Title: MEETING WITH ADVISORY COMMITTEE ON REACTOR SAFEGUARDS (Public)

**U.S. NUCLEAR REGULATORY
COMMISSION MEETING WITH
THE ACRS**

December 6, 2019

Figure 1. Estimates of the residual (RG 1.99, Revision 2 predicted minus measured values) of ΔT_{NDT} using the current US and international database for (a) welds and (b) base metal.

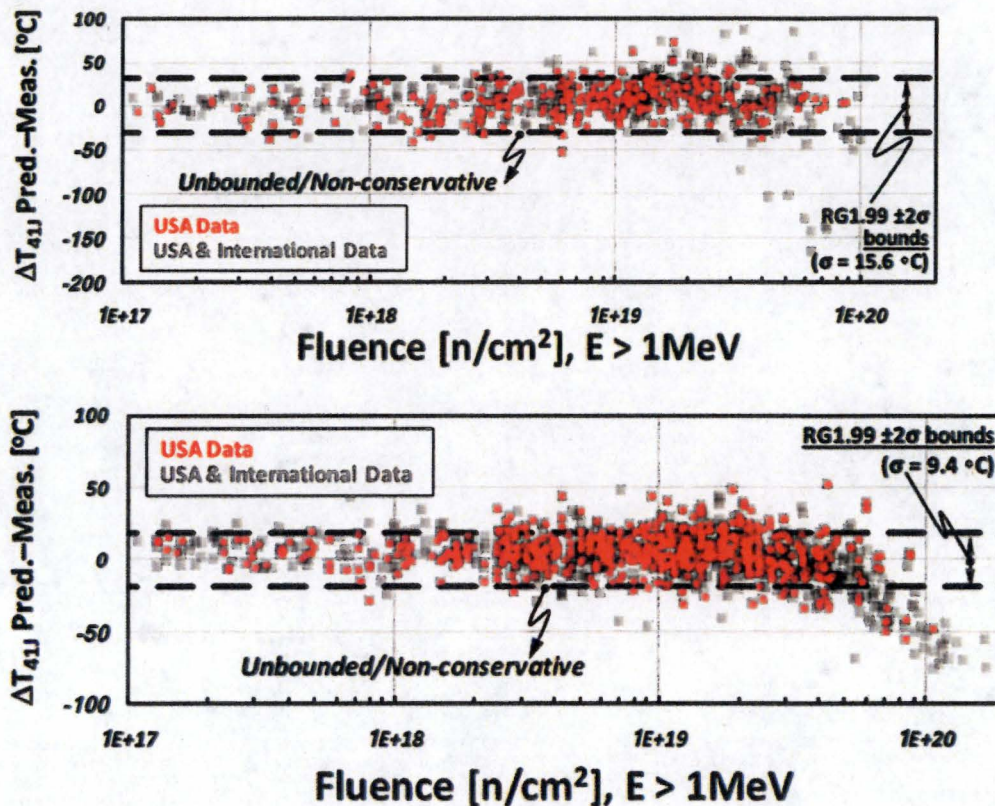
- Non-conservatism at high fluence for base metals
- Inaccuracies for reactor vessel materials with low copper content
- Underestimated standard deviation relative to the current database
- Conservative bias at low-to-mid fluences
- Lack of temperature adjustment

These deficiencies raise potential safety margin issues because resulting estimates of reference nil-ductility transition temperature shift (ΔRT_{NDT}) may be non-conservative for plants with vessels exposed to higher levels of neutron fluence anticipated during subsequent license renewal. Figure 1 contains plots of the residual of ΔRT_{NDT} for both welds and base metal. Residuals are computed as the difference between the RG 1.99, Revision 2 predicted value and the measured value from the current large embrittlement data base, incorporating both US and international data. A negative residual value indicates non-conservatism. The technical letter report analysis suggests that between fluences of 3×10^{19} n/cm² and 6×10^{19} n/cm² ($E > 1$ MeV), the mean residual becomes increasingly non-conservative.

Standard deviation values from the RG are used as a defined margin in RPV embrittlement calculations (horizontal dash lines in Figure 1). The current large embrittlement database has a larger standard deviation (greater scatter) than the original database used to develop the ETC in the RG. This represents another potential non-conservatism.

- Recommend an alternative ETC.
- Determine limitations of ETC implementation.
- Determine how to apply individual plant surveillance data.
- Determine margins on ETC.
- Determine default values for inputs that are not available.
- Write a draft revised RG for internal review.

The staff working group has adopted the correlation in ASTM E900-15. Completion of the tasks identified by the working group will provide a sound basis for revision of the RG. The working group also presented a schedule for completion of the identified tasks and development of a draft revised guide.
